Technical Service Bulletin

NUMBER: 08-21-00

Antenna Mast Installation

2000 – 2001 (PL) Neon

FIGURE 1

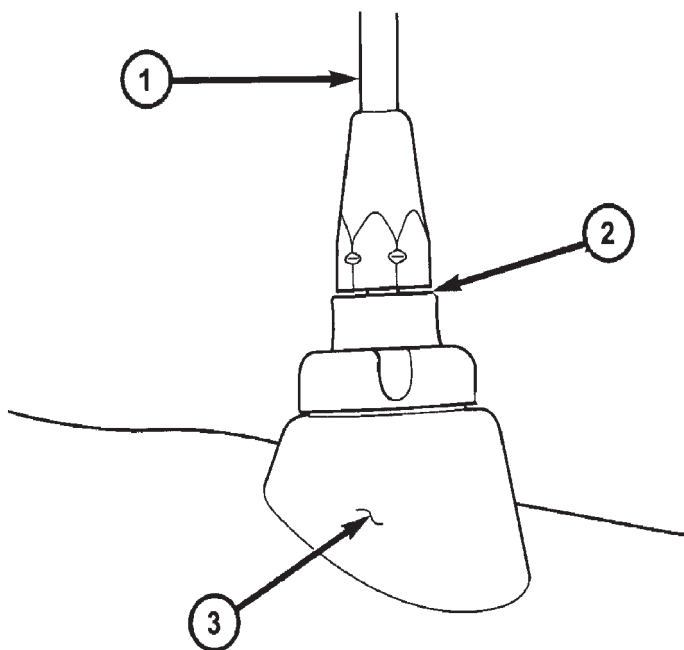
The Neon antenna mast is installed at the dealership during new vehicle preparation. Recently antenna masts have been coming into the material return center with mounting surfaces stripped. The Neon antenna should be torqued to 3.2 Nm (28 In. lbs.). With the antenna mast torqued to the proper amount (3.2 Nm (28 in. lbs)) there will be a slight gap between the mast and the base (Figure 1). The gap is there to ensure that there is no contact between the bottom of the antenna mast and the plastic surrounding the metal insert on the base. **Do not attempt to close the gap between the antenna mast and the base.**
